## Addendum No. 3

**Project:** 2016 Addition & Renovations  
**North Harrison Middle School**  
Ramsey, Indiana

**Proj. No:** 1518.01

**Date:** December 10, 2015

Sheet  
**AD-3.6**

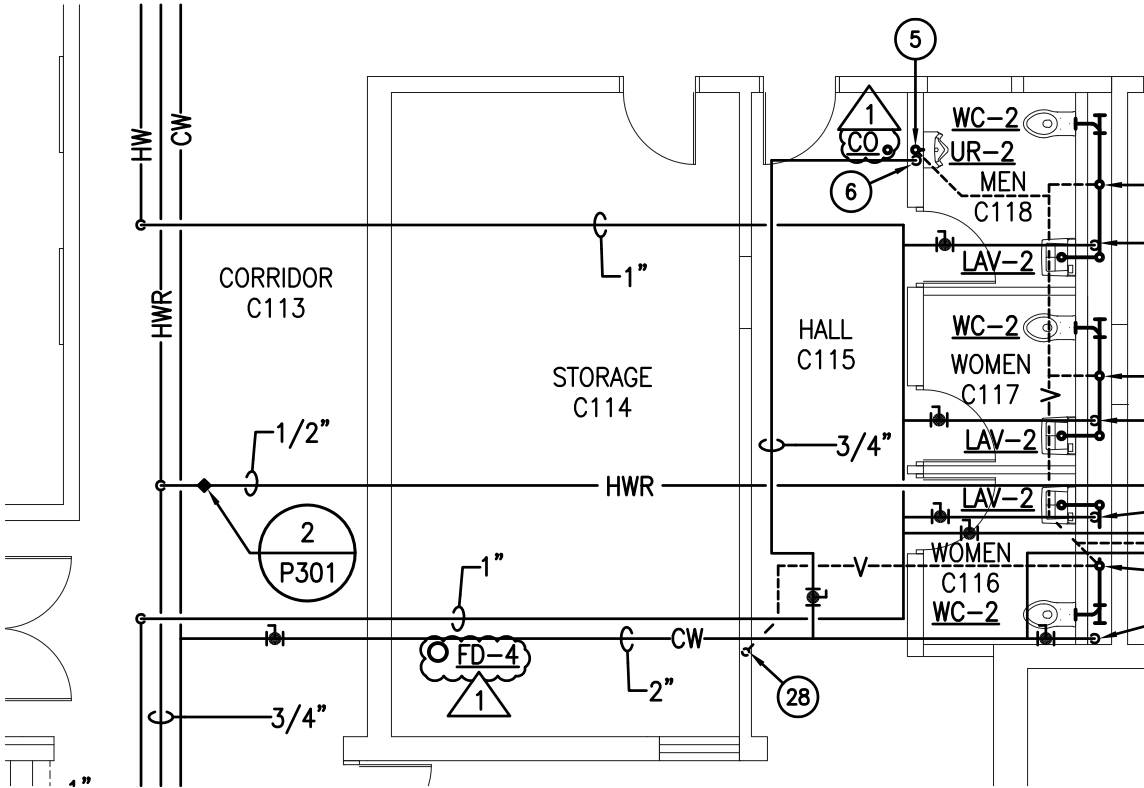
25. Sheet P-201  
Change Plumbing Fixture designation at sink in Conference A108 from SK-1 to SK-9.
26. Sheet P-202  
Add attached Drawing AD-3.6 in its entirety. Drawing changes Plumbing Fixture designation of one (1) water closet in Boys B115 and one (1) water closet in Girls B116 from WC-1 to WC-2.

Sheet  
**AD-3.7**

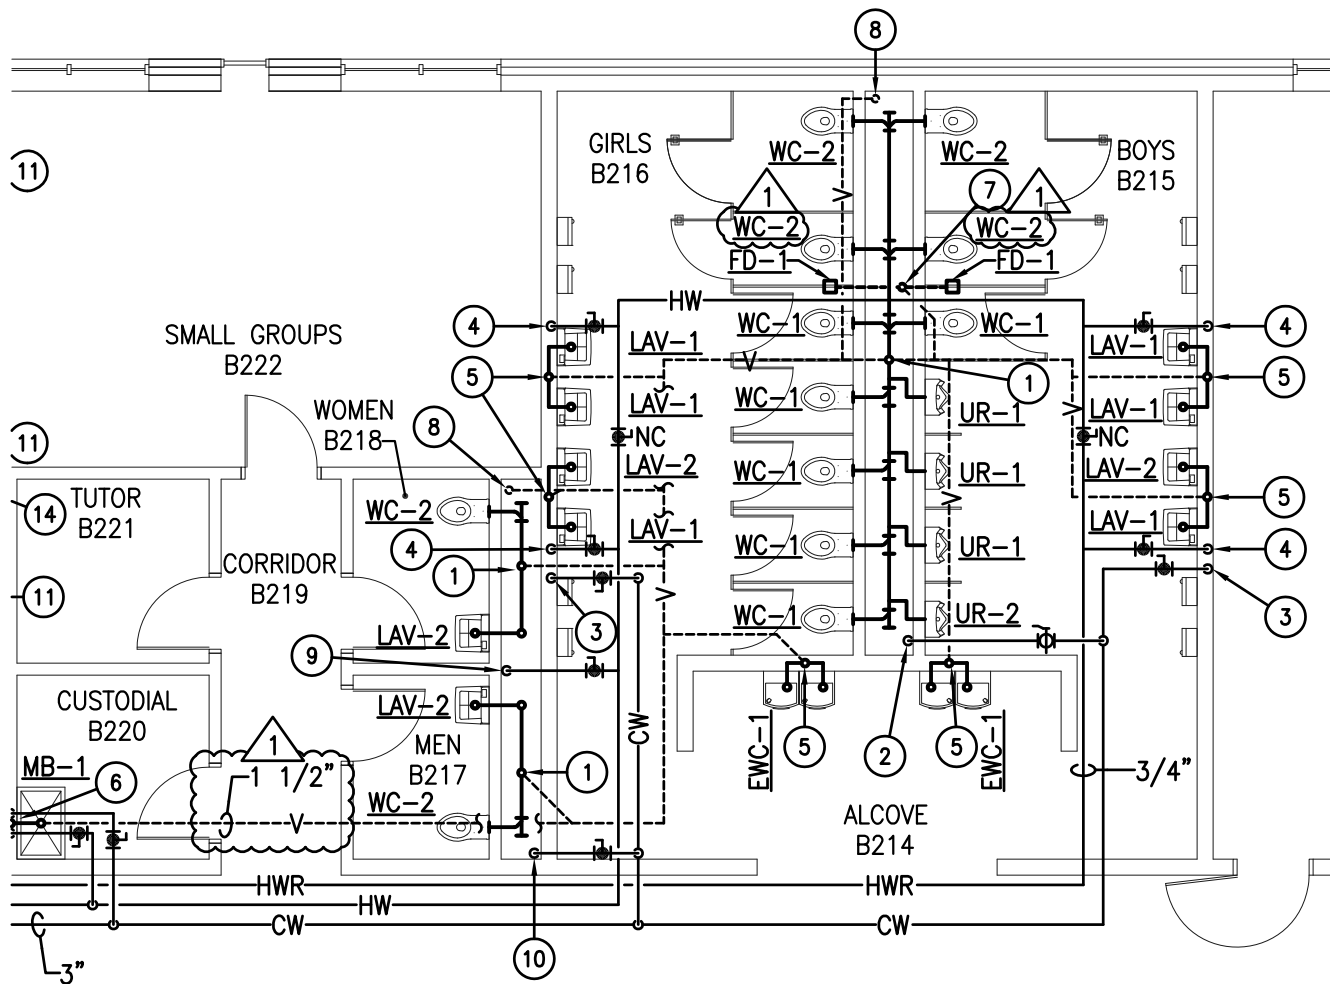
27. Sheet P-203  
Add attached Drawing AD-3.7 in its entirety. Drawing relocates floor drain FD-4 in Corridor C113 to Storage C114 and adds floor cleanout CO in Hall C115.  
Change Reference Note 17 to read: Contractor shall provide 1" CW and 1" HW overhead connections to UDS. UDS Manufacturer shall provide hoses for final connections to equipment by this Contractor.  
Change Reference Note 24 to read: 3" waste riser to floor sumps Item 51 and Item 57.  
Delete Plumbing Fixture designation FD-8 at drain in Cafeteria C111. Drain will be provided by Owner's separate Food Service Equipment Contractor.

Sheet  
**AD-3.8**

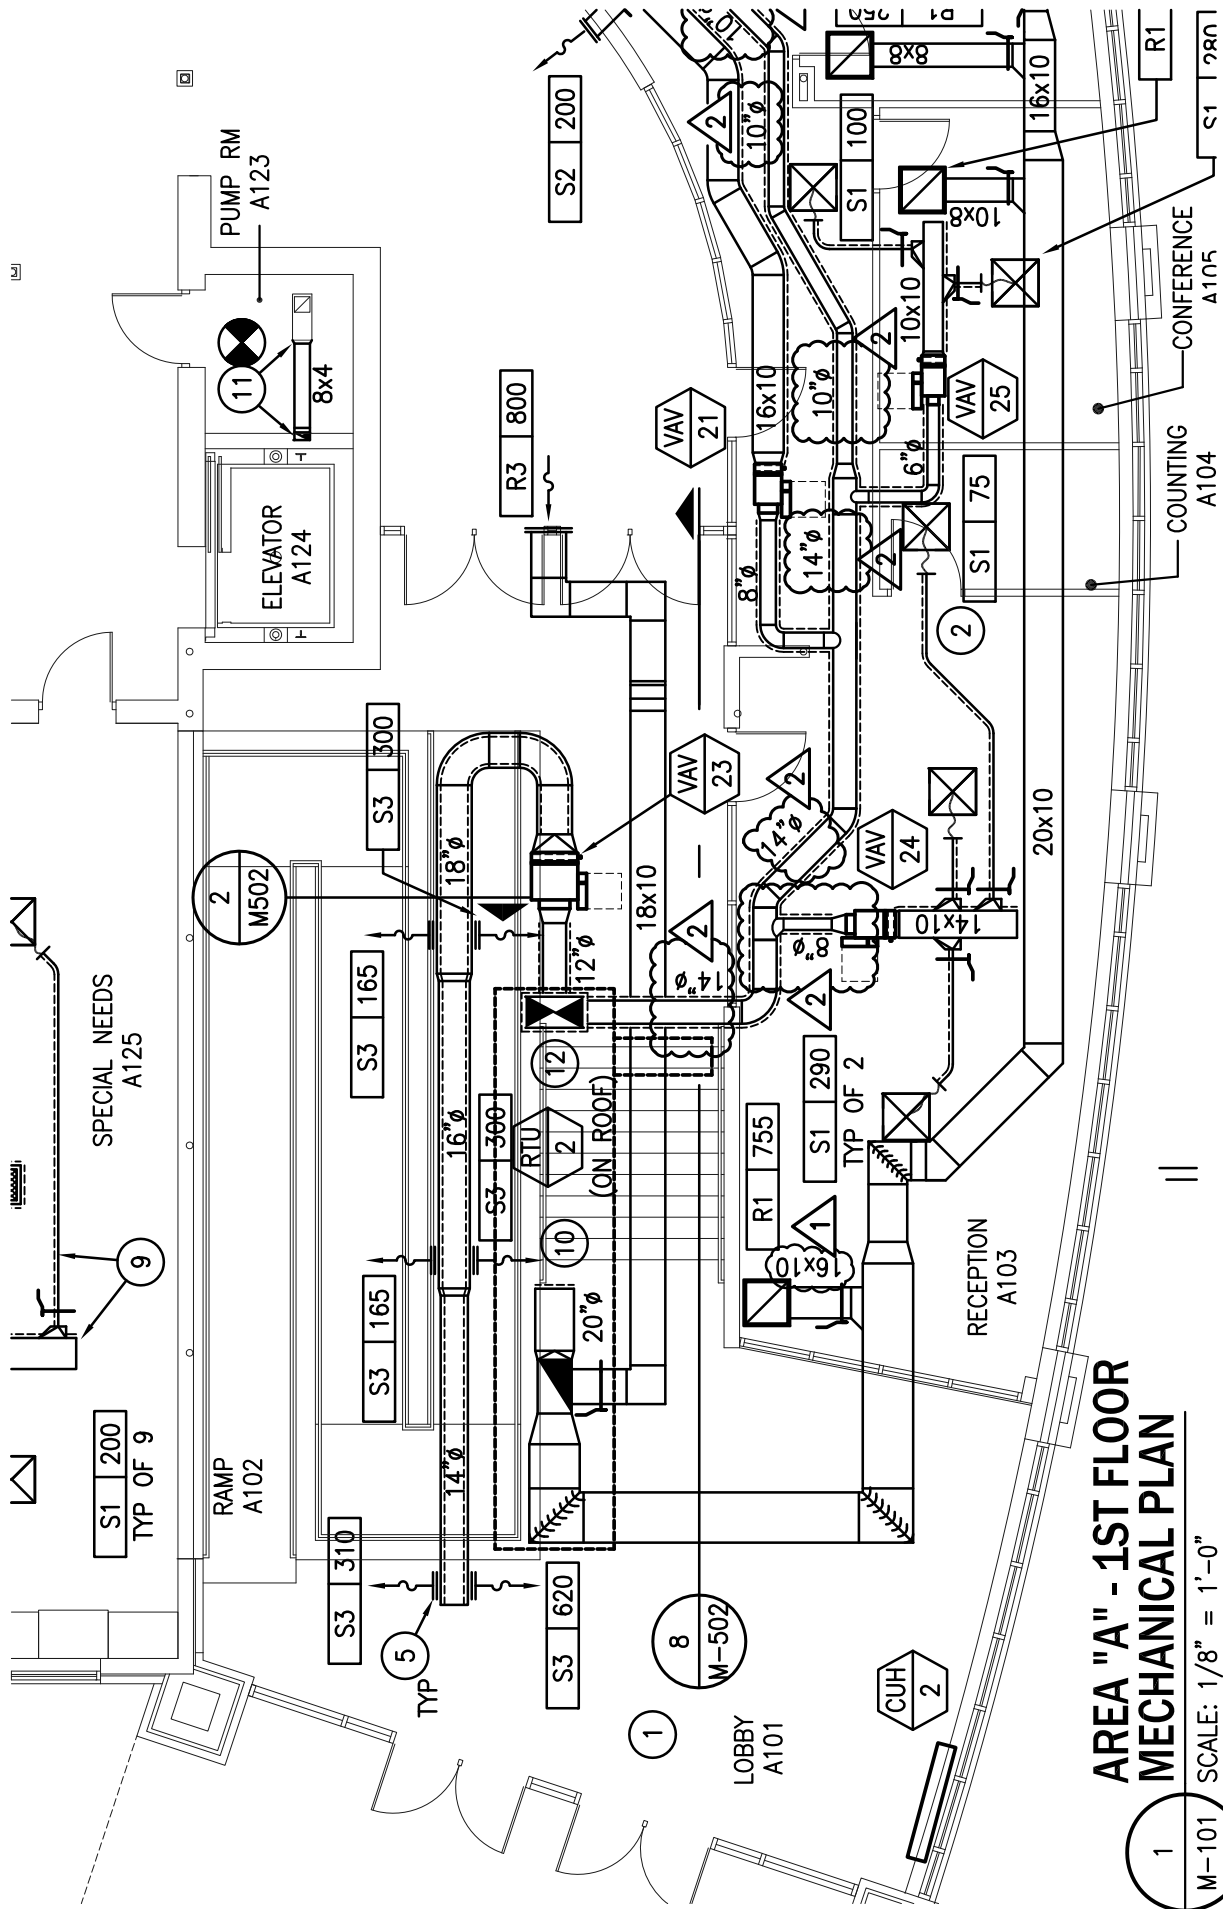
28. Sheet P-206  
Add attached Drawing AD-3.8 in its entirety. Drawing changes Plumbing Fixture designation of one (1) water closet in Boys B215 and one (1) water closet in Girls B216 from WC-1 to WC-2.

**AD-3.11**

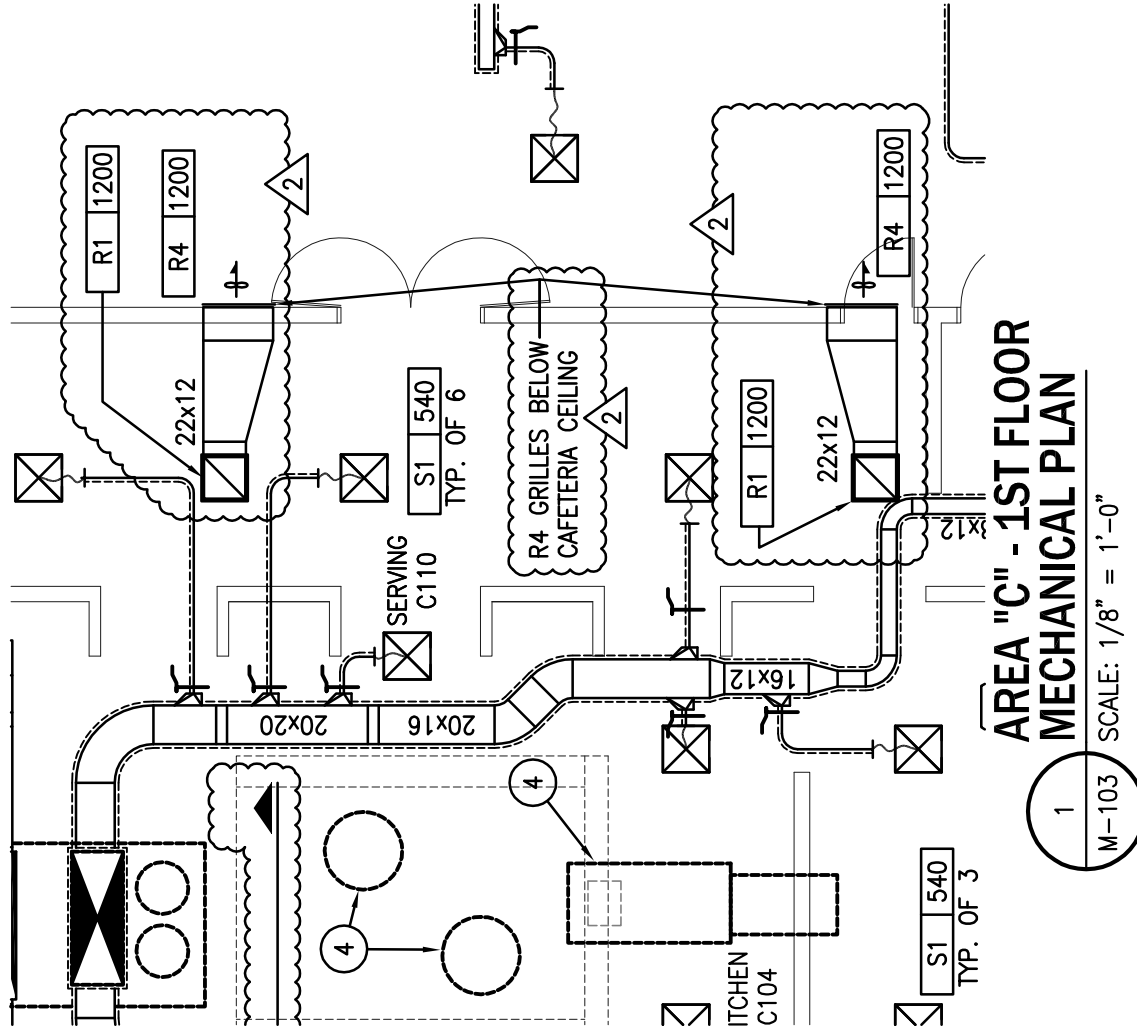
35. Sheet M-502  
Supply duct main taps now shown as boot taps per attached Drawing AD-3.11 in Media Center.
36. Sheet M-603  
Unit Ventilator Sequence of Operation: 4. Economizer Cooling  
Add the following item: "E. At UV-14, the return damper shall close during economizer mode."

Sheet  
**AD-3.12**

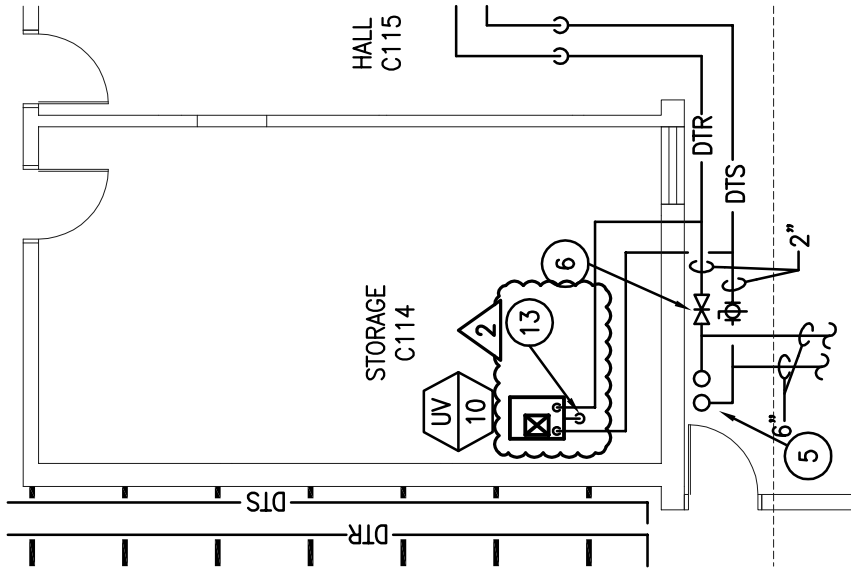
32. Sheet M-103  
Add attached Drawing AD-3.12 in its entirety. Drawing illustrates changes to cafeteria/kitchen area transfer grilles.
33. Sheet M-203  
Add attached Drawing AD-3.13 in its entirety. Drawing illustrates condensate piping to floor drain for UV-10.  
Add new Reference Note 13 to read: "Drop 1" condensate to floor drain located in room C114.
